A29 PHASE 1

Environmental Statement Addendum

PROJECT NO. 70079718

DATE: MAY 2021

Figure 2-1 –North of Fontwell Avenue - Originally Submitted Red Line Boundary

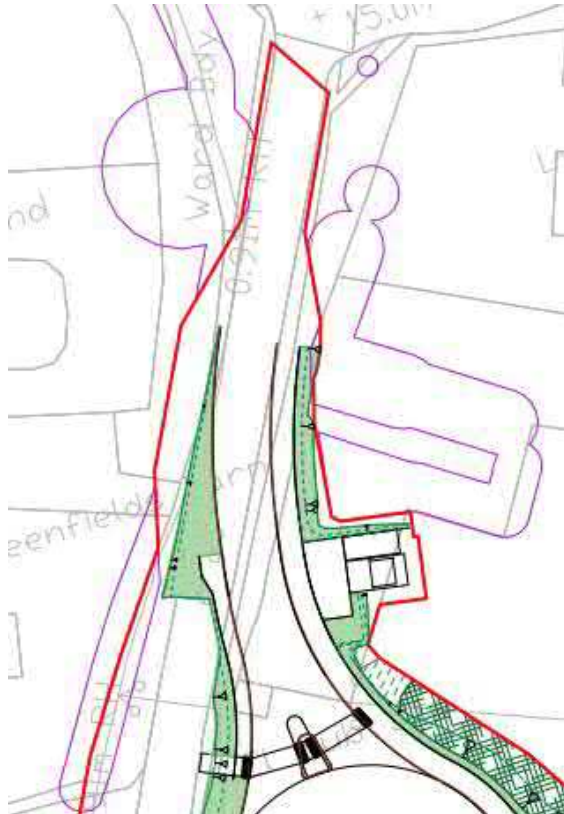
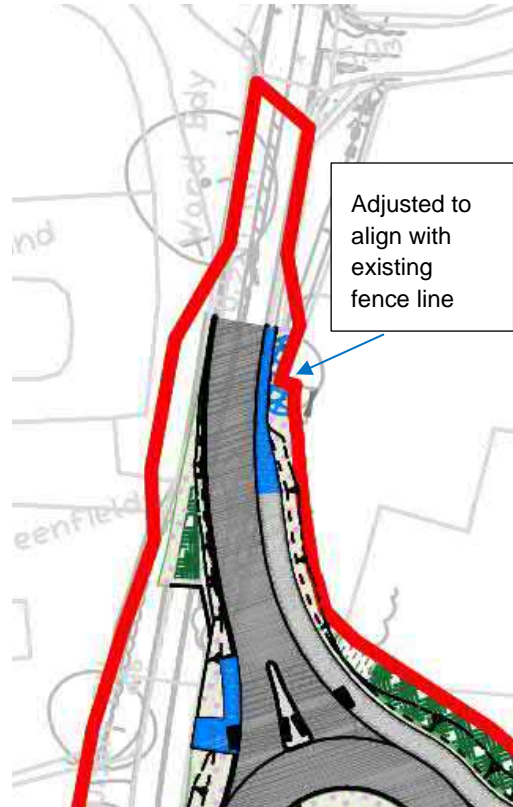
2.2.1. This amendment is shown on the Site Layout Plan drawing no. A29-CAP-HPN-00-DR-C-0132 S0-P07 (**Appendix 2.1** of this ES Addendum). Due to restrictions on land availability in the location originally identified for the electricity substation, as shown in Figure 2.1 below, an alternative location is proposed, and this is discussed further at Section 2.3.

2.2.2. The relocation of the electricity substation and its associated parking area results in a realignment to the RLB as shown in Figure 2.2 below (refer to A29-CAP-HPN-00-DR-C-0239 S0-P03 in **Appendix 2.3** of this ES Addendum for landscape details).

2.2.3. Just to the north of the original substation location, the RLB has been moved to minimise land take and align with the existing fence line.

Figure 2-3 - East of Fontwell Avenue - Revised Red Line Boundary

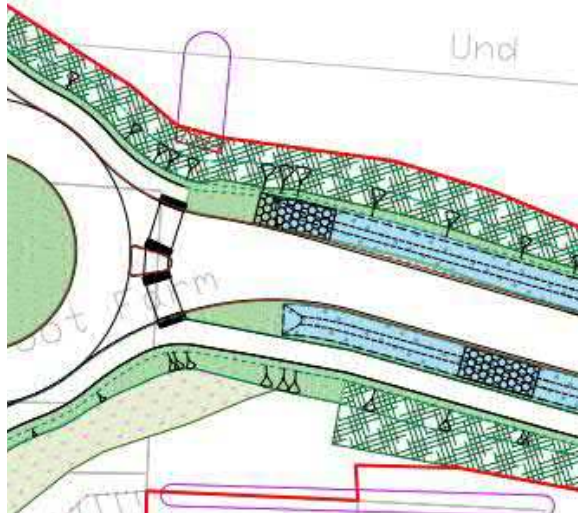
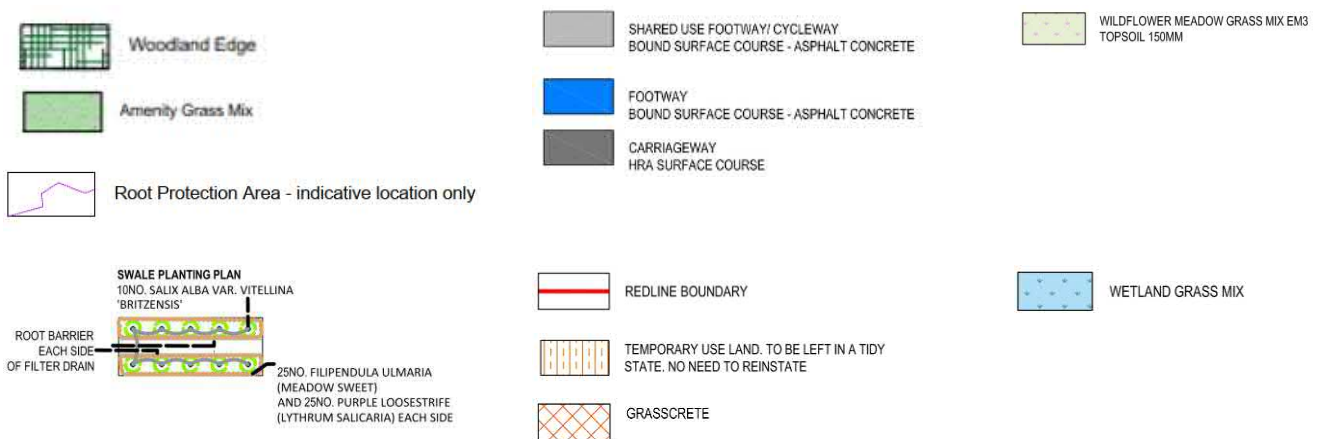
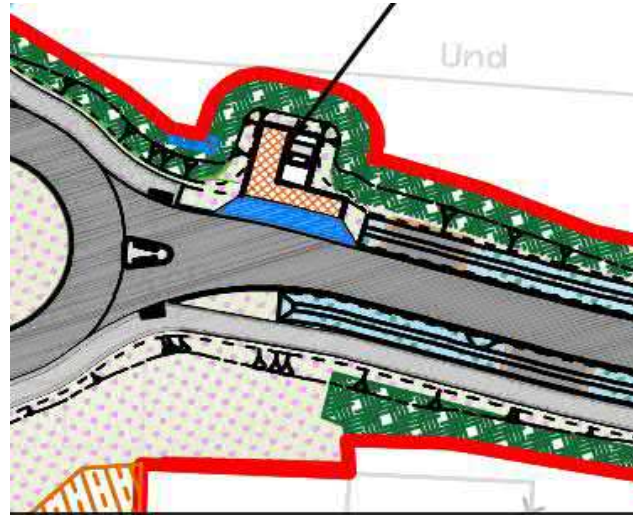
- 2.3.1. The new location for the electricity substation is also shown on the Site Layout Plan drawing no. A29-CAP-HPN-00-DR-C-0132 S0-P07 (**Appendix 2.1** of this ES Addendum). The proposed substation will now be installed approximately 40 m to the north east of the Fontwell Avenue Roundabout and would have a GEA of 100m² (including parking area). The proposed electricity substation cross section is shown on drawing ref A29-CAP-HPN-00-DR-C-0235 S0-P02 **Appendix 2.2**. The proposed glass reinforced plastic (GRP) enclosure would measure 3.112m wide, 2.800m deep, and have a maximum height of 2.264m. Off street parking spaces are provided for service vehicles only.

- 2.3.2. The original RLB is shown in **Figure 2-3** and the revised RLB in **Figure 2-4** below. The electricity substation includes a grasscrete parking area, shown in orange, with the transformer enclosed within a new GRP kiosk. The landscape design has been amended to accommodate this change, with woodland edge planting to the north. Planting in the swale shown on both sides of the carriageway has moved east to accommodate the new substation.

Figure 2-6 – Halo Entrance - Revised Red Line Boundary

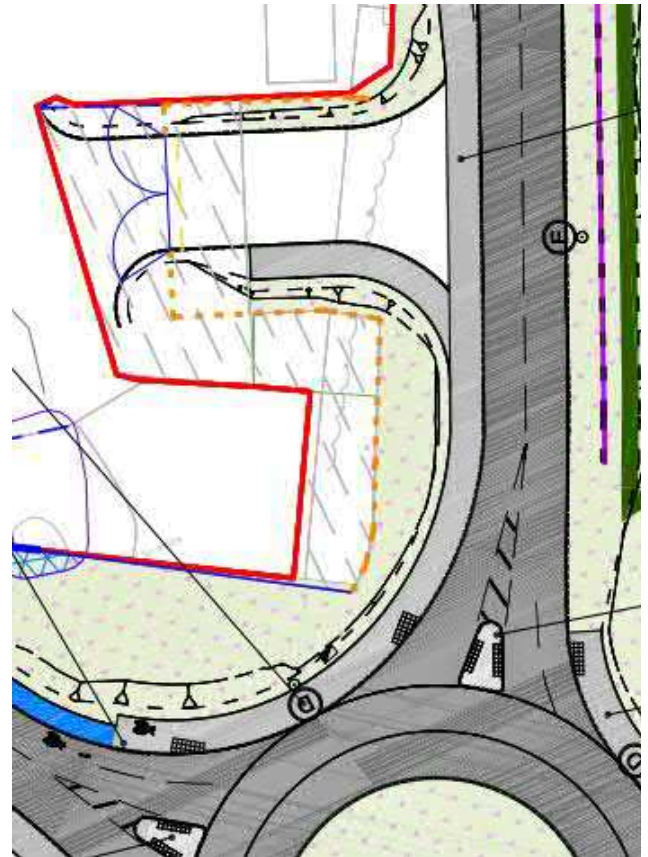
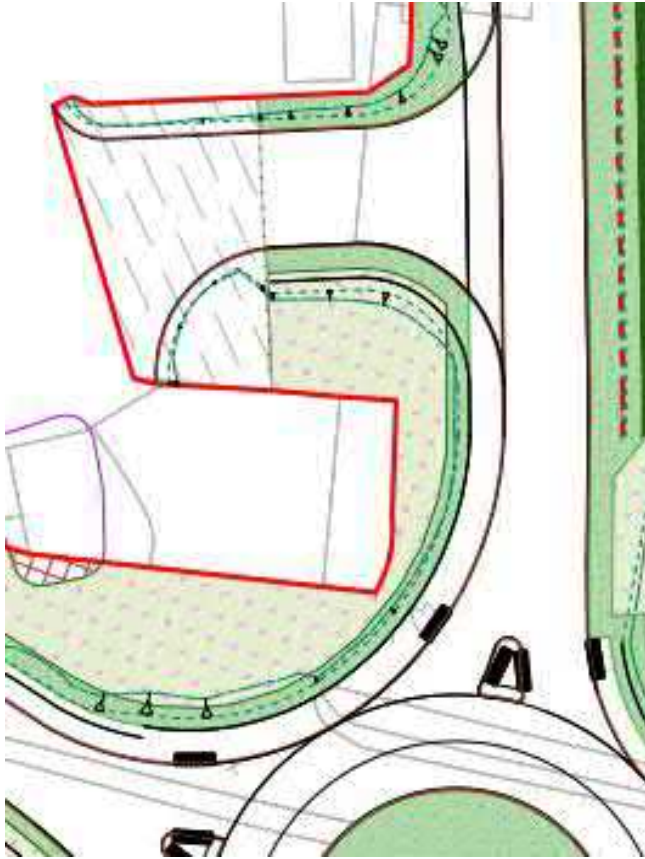
- 2.4.1. Detailed design has advanced and fence lines to the south of the Fordingbridge Industrial Estate (Halo) entrance have been adjusted. As a result, the RLB has extended 6m further west. This amendment has been required due to late changes in land ownership boundaries that will require fence lines to be adjusted as part of the works.
- 2.4.2. The RLB changes at the Halo entrance are shown in **Figure 2-5** and **Figure 2-6** below and A29-CAP-HPN-00-DR-C-0135 S0-P08 in **Appendix 2.1**. The RLB has been adjusted to align to the west of the property boundary. Boundary fencing comprising close board fence panels with green mesh security fence, to match the existing Halo fence will be installed.
